Ref: BCC 783

Planning Application: Capital Interchange Way.

The BCC have now reviewed the application version of the scheme and they have asked me to write to you to request that you include these observations in your report to members.

Appendix A.: Site Plan showing application site high rise development and the flats on the adjacent Brentford Football Club site.

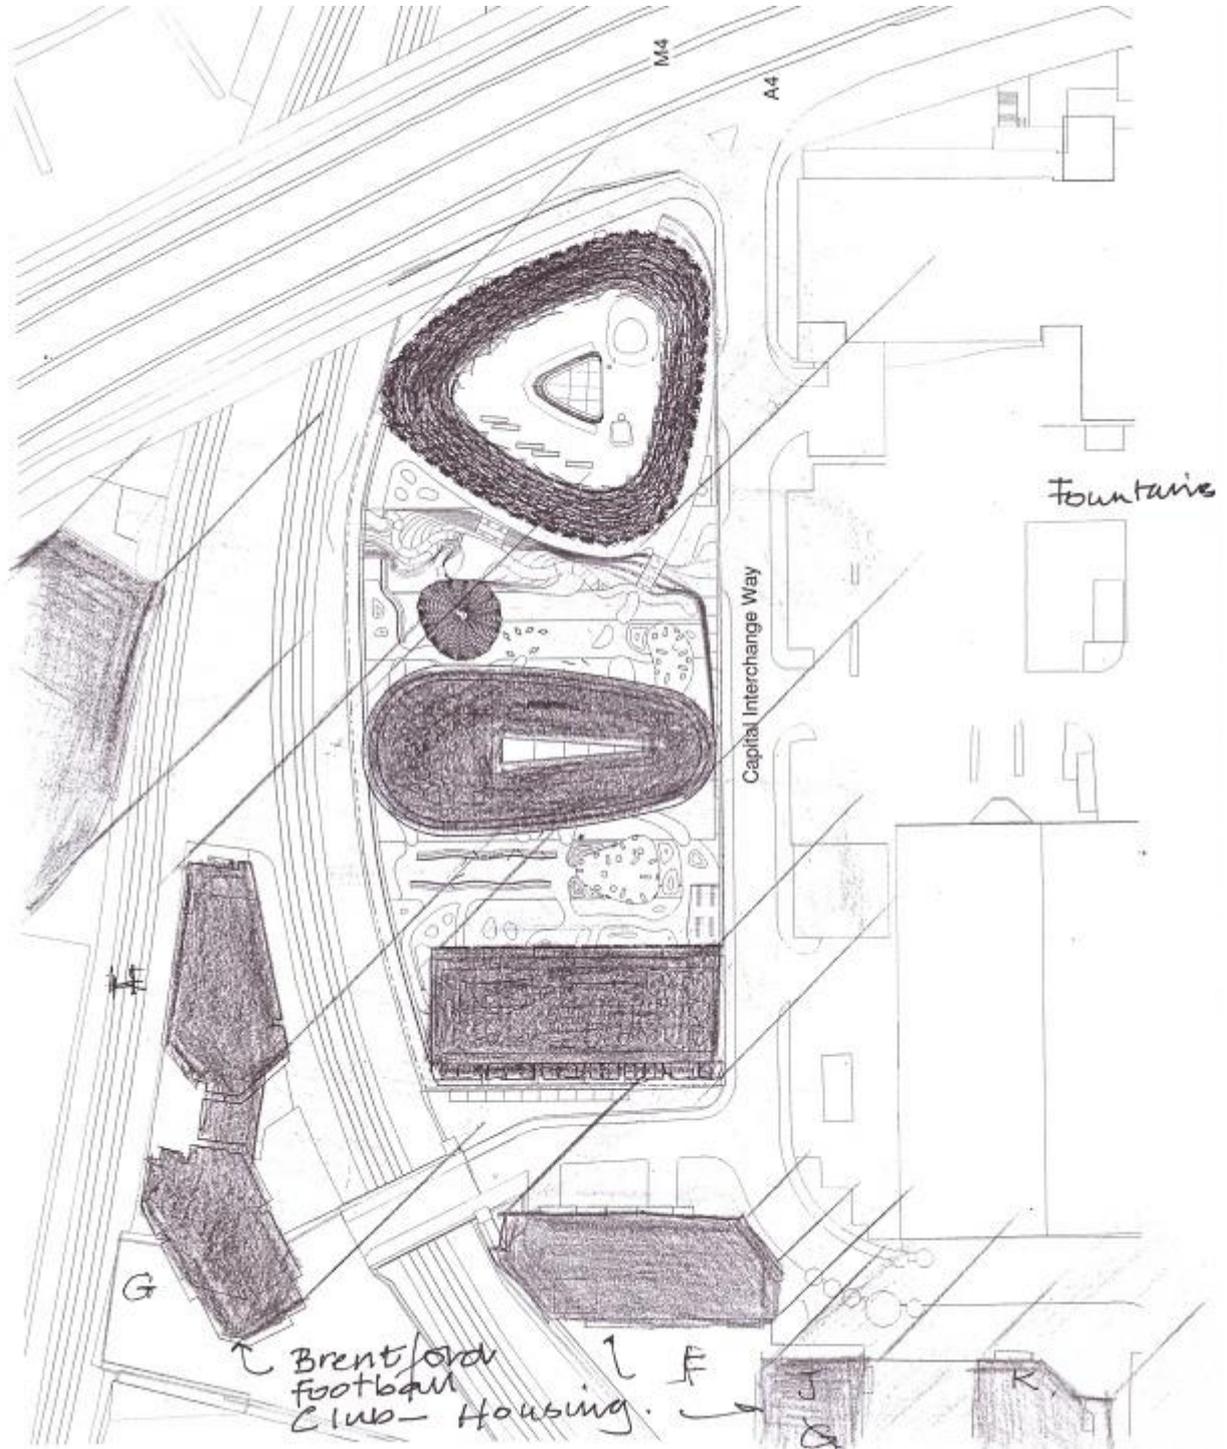
6.01. Appendix A shows the relationship between the application site, the existing Fountain Centre and the Brentford Community Stadium and its associated housing, which has full planning consent.

6.02. It appears that neither the Environmental Statement Volume 3: Built Heritage, Townscape and Visual Impact Assessment nor the Environmental Statement Appendices (Vol 4) take any account of the proximity of the site to blocks G,H and I of the BFC complex.

6.03. Without this information the planning committee will not be able to judge either the way these two schemes will be seen together nor the quality of the spaces between.

15.07. Actual enjoyment might be further reduced in the large areas shaded by the high buildings on this site and on the adjacent BFC site, by exposure to wind, dust and grit from the adjacent road traffic and from excessive noise. (See paras 12/14 above). (See Appendix A).
